BLAINE COUNTY PLANNING AND ZONING COMMISSION
Public Hearing Date: April 13, **May 25, and June 8, 2023**

REGARDING THE APPLICATION OF: Chris and Marcella Dornin for a Mountain Overlay District (MOD) Site Alteration (site alt) permit application to construct a swimming pool with associated retaining walls, decking and landscaping at 126 Alpine Drive.	STAFF REPORT By: Rachel Martin Date: May 16, 2023 New comments in red
--	--

Requested Action: Public Hearing and consideration of a MOD Site Alteration Permit application by Chris and Marcella Dornin, to construct a 1,125 square foot, 15' x 75' swimming pool with associated retaining walls, decking and landscaping at 126 Alpine Drive, Lake Creek Subdivision Amended, Block 3, Lot 47A. The lot is zoned Rural Residential District (R-10), Low Density Residential District (R-1) with Mountain Overlay, Avalanche Overlay and Wildlife Overlay Districts.

Boulder Wall Example

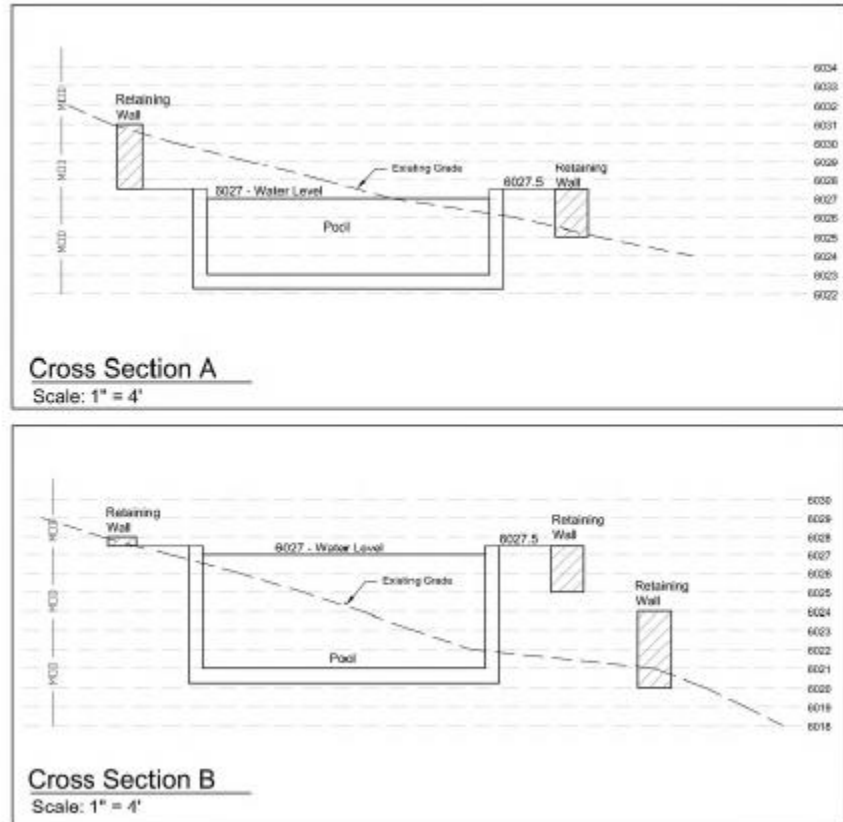
► **Staff Comment:** The 1,125 square foot swimming pool does not seem to be visible because of the sunken nature of an inground pool. However, the retaining walls, which make the pool possible, will be visible. The lower retaining wall at its highest point is 6 feet from natural grade. A second lower wall extends another 3 feet with a total of 9 feet of retainage below the pool. The upper retaining

wall is sloped with a maximum height of 5.5 feet above the pool. Retaining wall materials may be boulders as shown on page L2 of the plan set and below.

- **DESIGN:** The need for hillside retainage may make this location more visible than the 2018 location. Lighting will increase the visibility. The proposed lighting does not meet the Outdoor Lighting Chapter requirements.
